Attachment 4

Proposed Tech Spec Change Retyped

Figure B 3.6.6-2
CRFC and Containment Post-Accident Charcoal Systems

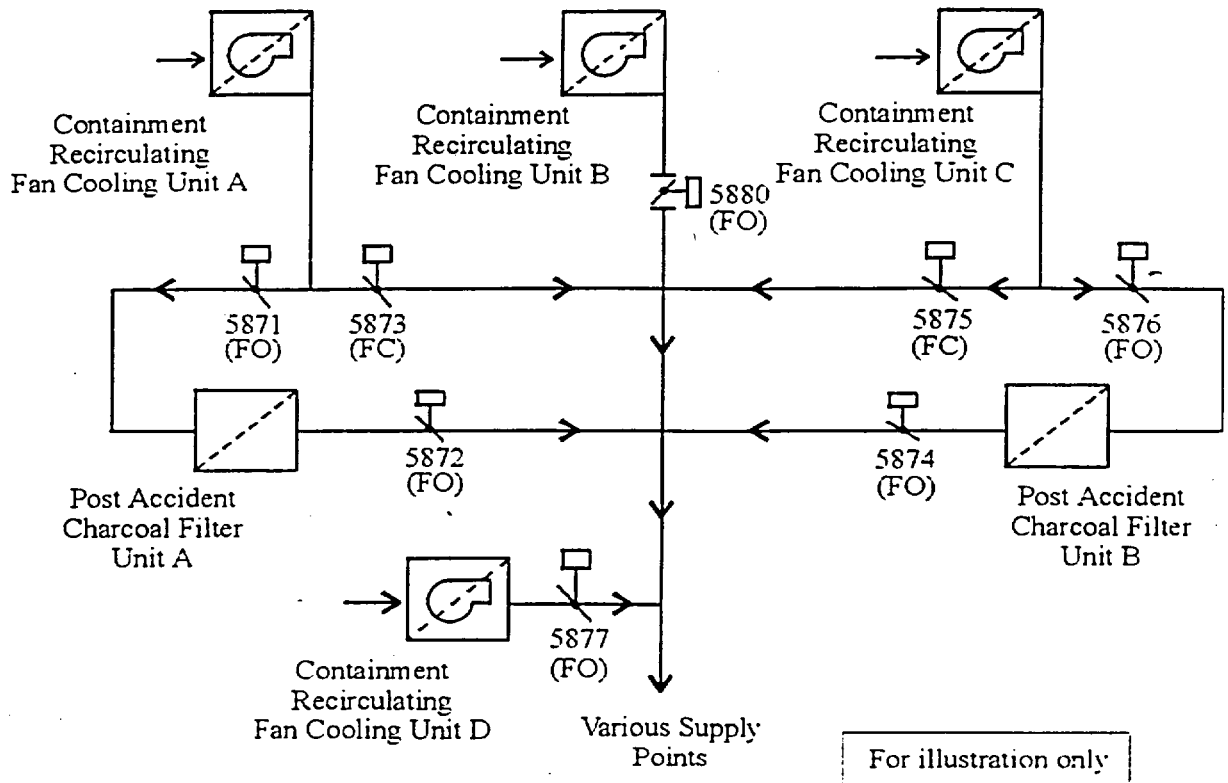
~~The Containment Post-Accident Charcoal System consists of two redundant, 100% capacity trains. Each train includes an airtight plenum containing two banks of charcoal filter cells for removal of radioiodines (see Figure 3.6.6-2). Air flow enters the plenum through two holes in the bottom (one at each end), passes through the charcoal filter banks to the center, and is exhausted from the plenum through a hole in the top. Two normally closed air operated dampers isolate each post-accident charcoal filter train from CRFC units A and C (dampers 5871 and 5872 for Train A and 5874 and 5876 for Train B). A SI signal opens these dampers and closes two bypass dampers from the CRFC units (dampers 5873 for CRFC unit A and 5875 for CRFC unit C) to force flow through the post-accident charcoal filters.~~

~~Required Action F.1 is modified by a Note which states that this required action is only applicable if CRFC unit A or C is inoperable. The loss of CRFC unit A or C results in the associated post-accident charcoal filter train being inoperable since the post-accident charcoal filter trains do not have their own fan assembly.~~

Figure B 3.7.9-1
CREATS

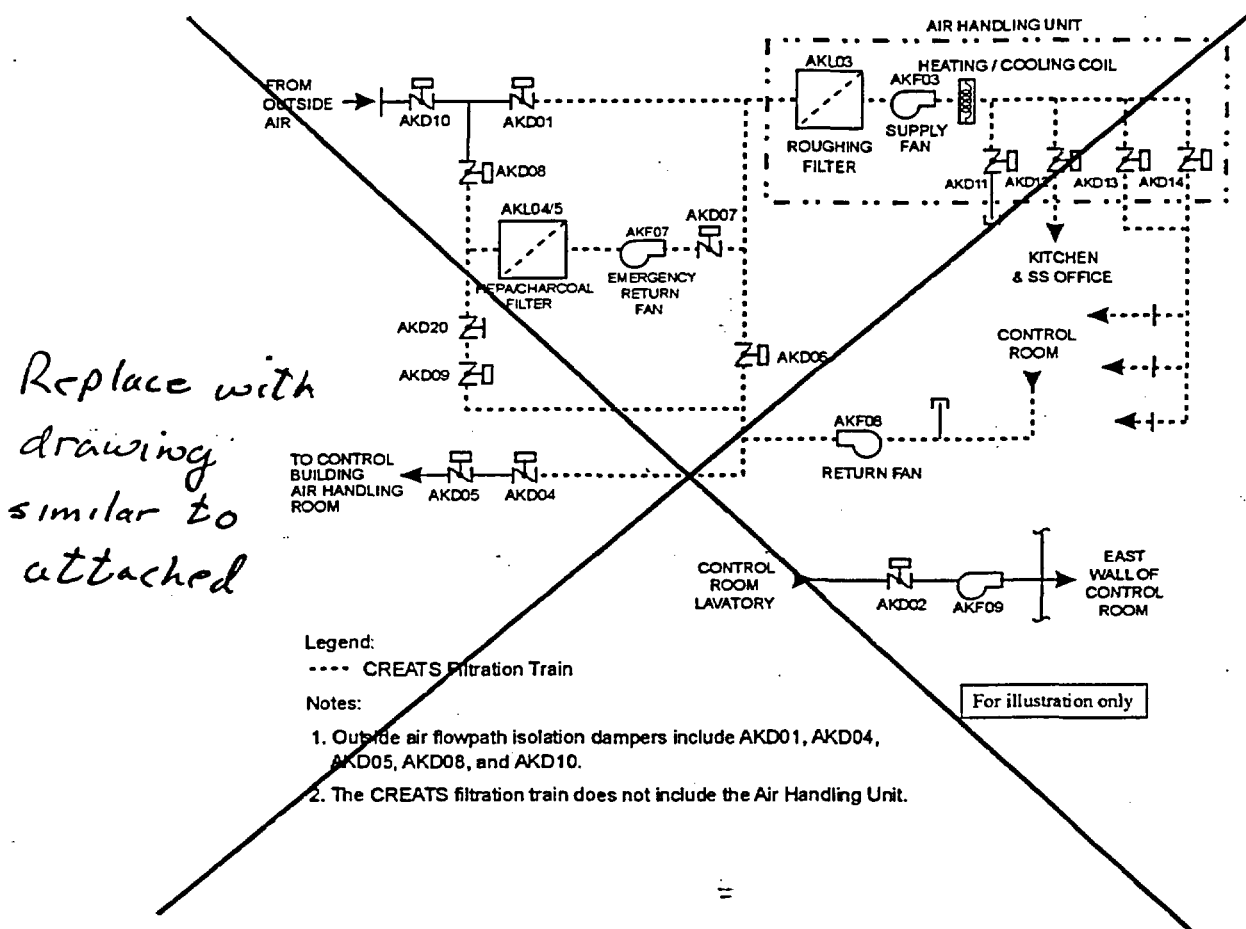
*Replace with
attached*

CREATS The ~~GREFS~~ consists of two independent, redundant trains that recirculate and filter the control room air. Each train consists of a prefilter ~~or demister~~, a high efficiency particulate air (HEPA) filter, an activated charcoal adsorber section for removal of gaseous activity (principally iodines), and a fan. Ductwork, valves or dampers, and instrumentation also form part of the system, ~~as well as demisters to remove water droplets from the air stream~~. A second bank of HEPA filters follows the adsorber section to collect carbon fines and provide backup in case of failure of the main HEPA filter bank.
